### APPEAL SUMMARY

<b>Appeal ID:</b> 20216	<b>Project Address:</b> NWC - SW 1st Ave and SW Pine St
<b>Hearing Date:</b> 4/10/19	<b>Appellant Name:</b> Milena Di Tomaso
<b>Case No.:</b> B-014	<b>Appellant Phone:</b> 5038632425
<b>Appeal Type:</b> Building	<b>Plans Examiner/Inspector:</b> John Cooley
<b>Project Type:</b> lur	<b>Stories:</b> 5 <b>Occupancy:</b> B, M, S-1 <b>Construction Type:</b> 3-A
<b>Building/Business Name:</b> PAE Living Building	<b>Fire Sprinklers:</b> Yes - Throughout
<b>Appeal Involves:</b> Erection of a new structure, Reconsideration of appeal	<b>LUR or Permit Application No.:</b> 19-124284-LU
<b>Plan Submitted Option:</b> pdf [File 1]	<b>Proposed use:</b> Office, Retail

#### Appeal item 1

1  
AP-1.5  
ELEVATION, EXTERIOR ENLARGED- WEST  
1/2" = 1'-0"

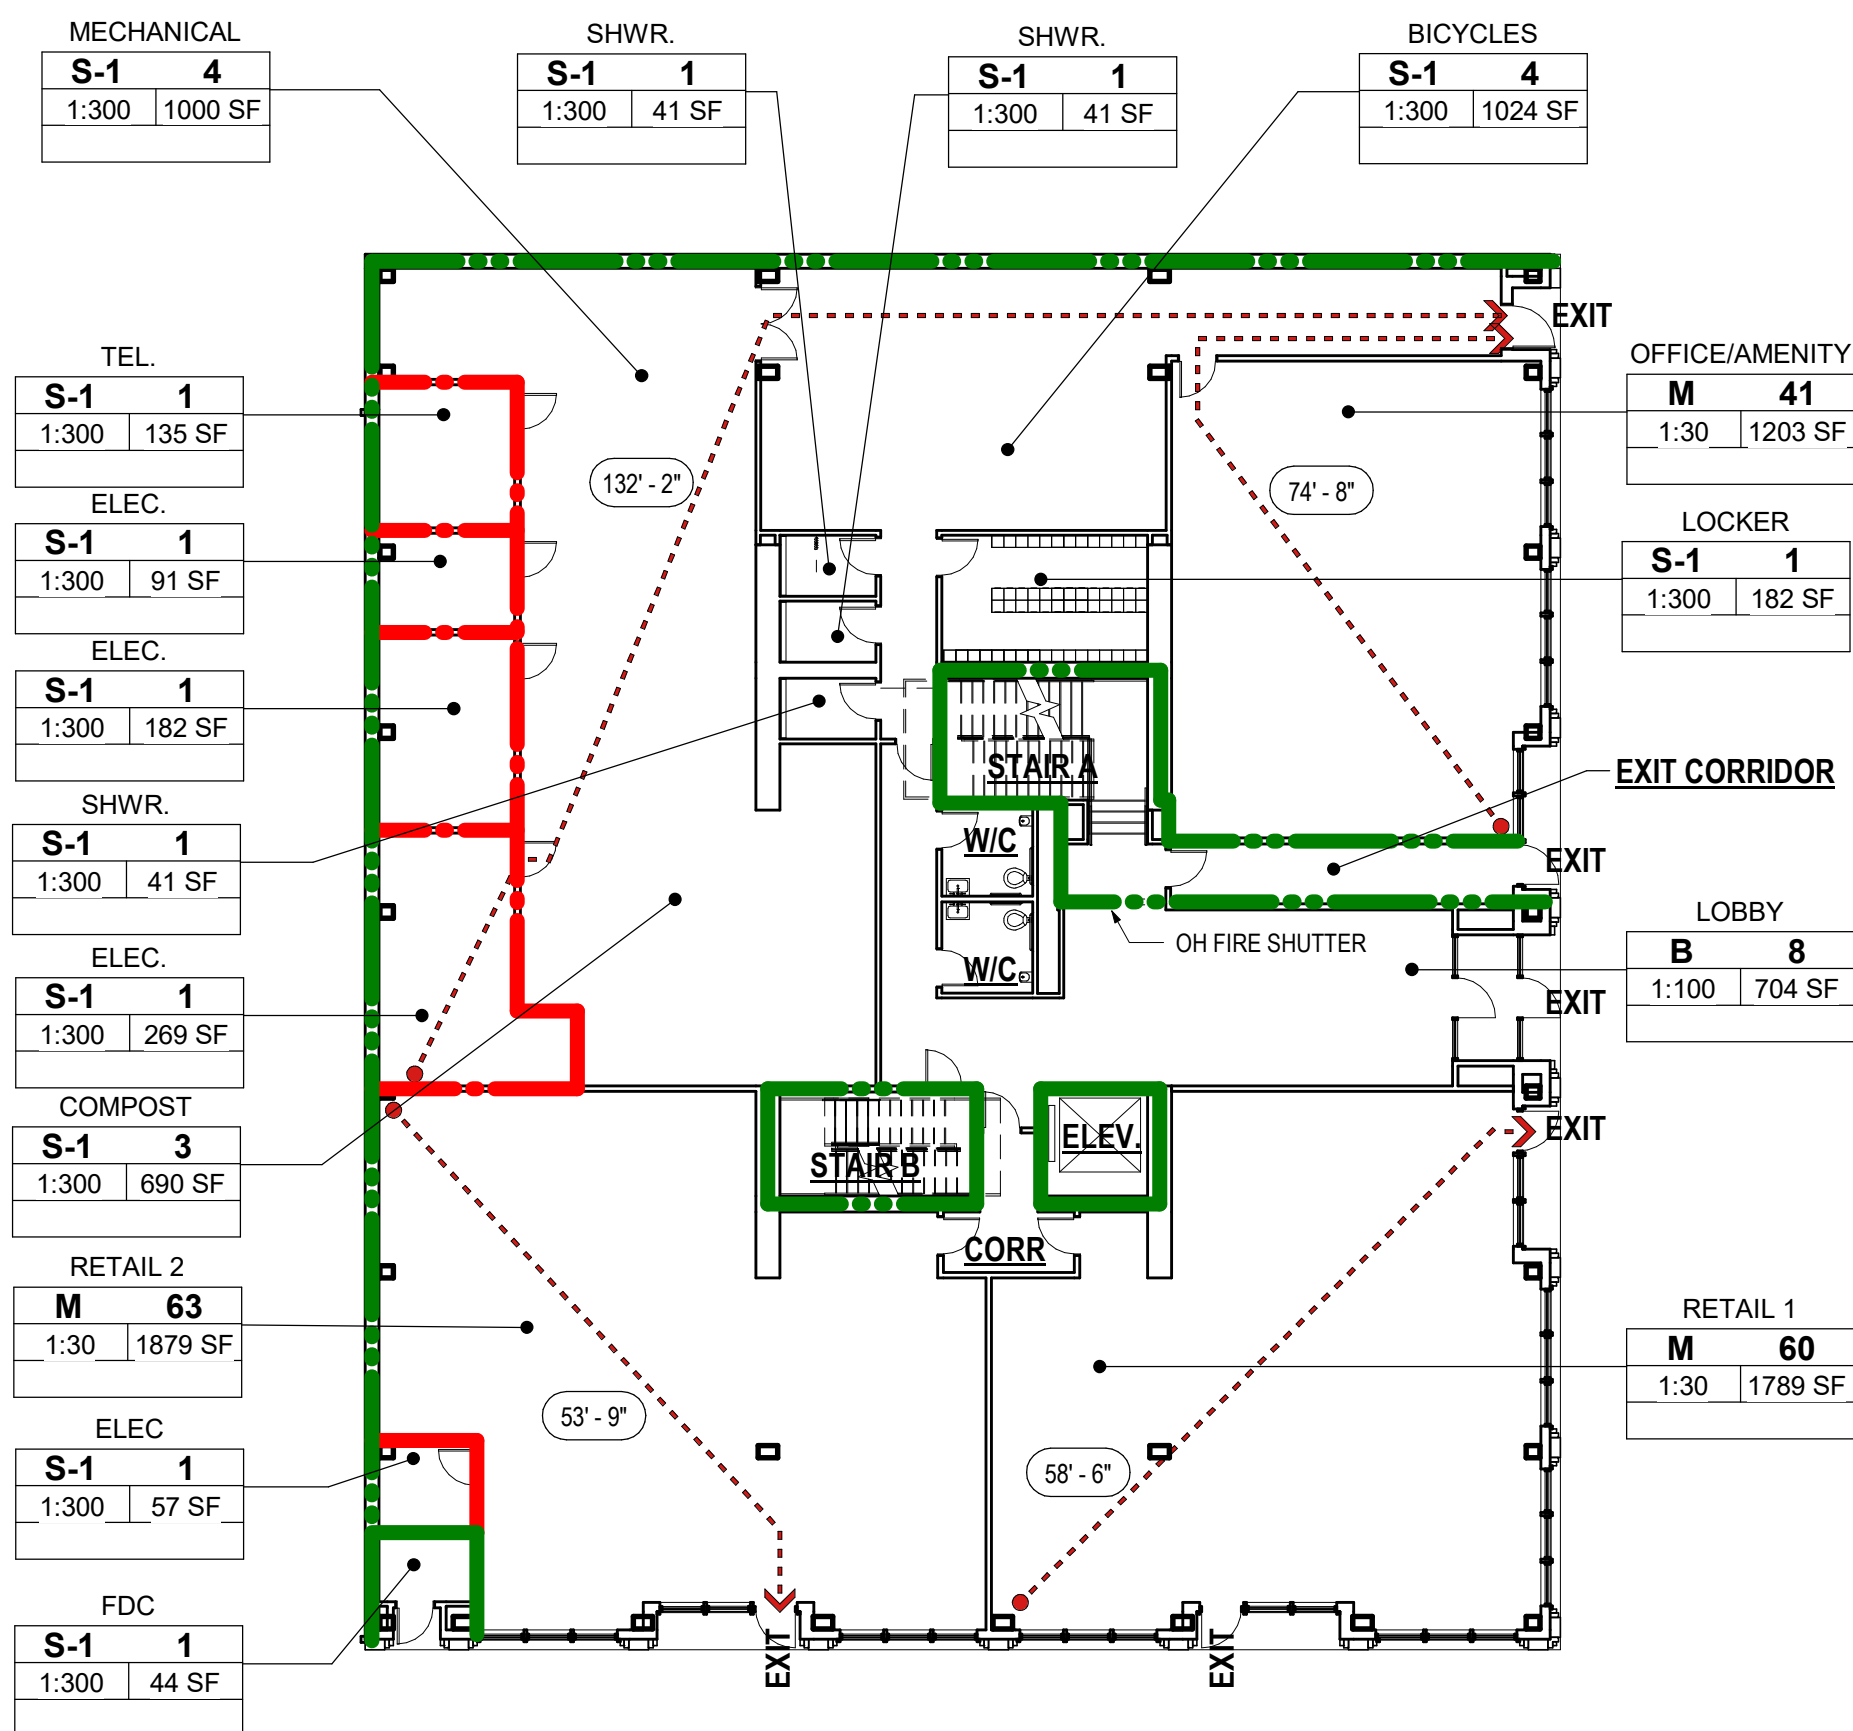
All proposed window openings on the west elevation are above the 15'-0" vertical separation distance from the adjacent roof structure on the west. All window openings will be unprotected. This proposed alternate is required for the project to meet its targeted certification under the Living Building Challenge. The "Civilized Environment" Imperative requires all workspaces (at the time of certification) to be within 30' of a window and/or manually operable mechanism to provide fresh air and daylight. Without the proposed windows, the building would not be economically viable as an office, as too much of the floor plate could not be regularly occupied as workspace; the project is already being zoned and designed with circulation, mechanical and office support spaces in "non-daylit" zones on the first, second, and third floors. As well, skylights are considered on the fifth floor, but they are limited in area so not to conflict with the necessity to maximize PV placement and renewable energy production to achieve the required net-zero energy performance under LBC, as well the necessity to provide fire department access and circulation around the perimeter of the roof.

All proposed window openings on the west elevation are above the 15'-0" vertical separation distance from the adjacent roof structure on the west. All window openings will be unprotected.

**1b. Openings in the West wall within 3 feet of the property line with no build easement above the roof of the adjacent building: Granted provided the easement is a minimum of 2 feet, 8 inches wide x 100 feet in length for the full length of the adjacent Pine Street Market building.**
